DOCKETED	
Docket Number:	23-OPT-01
Project Title:	Fountain Wind Project
TN #:	263379
Document Title:	County of Shasta Letter Comments - Attachment 1 Net Economic Benefits
Description:	County of Shasta Letter Comments - Attachment 1 Net Economic Benefits
Filer:	Kari Cameron
Organization:	County of Shasta
Submitter Role:	Public Agency
Submission Date:	5/27/2025 2:34:49 PM
Docketed Date:	5/27/2025

Response to Fountain Wind Staff Assessment: Net Economic Impact Analysis

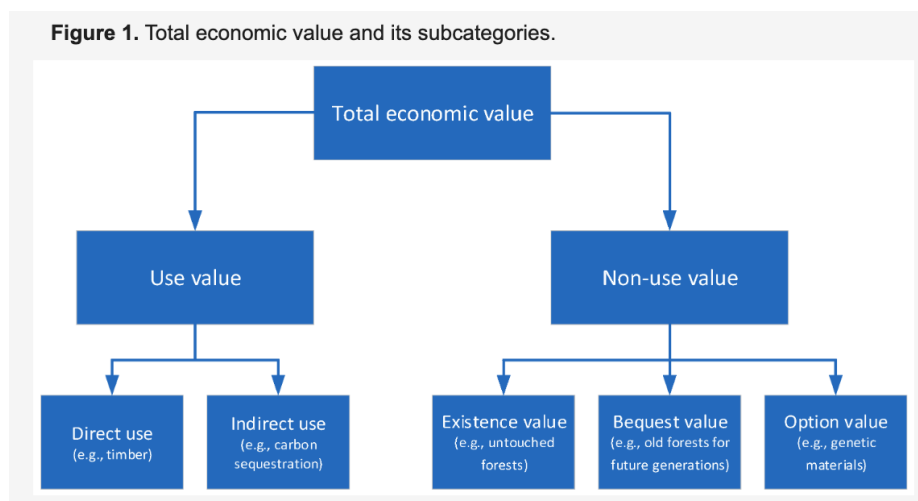
However, many would understandably argue that a forest is worth more than what it can be cut down and sold for. The direct market-based approach only incorporates part of the “use value” of the forest. Economic literature differentiates between the “use value” and “non-use value”, and considers both when calculating the total economic value of a forest.⁵ Essentially, the non-use value recognizes that forests have value other than simply being cut down and made into products. The forest itself provides a lot to nearby communities in the form of tourism, recreation, and many environmental benefits that have positive economic externalities such as flood mitigation. To encompass these additional benefits, there are several broader valuation methodologies that economists commonly use, as illustrated in the graphic below, from Nolander et al., 2024.
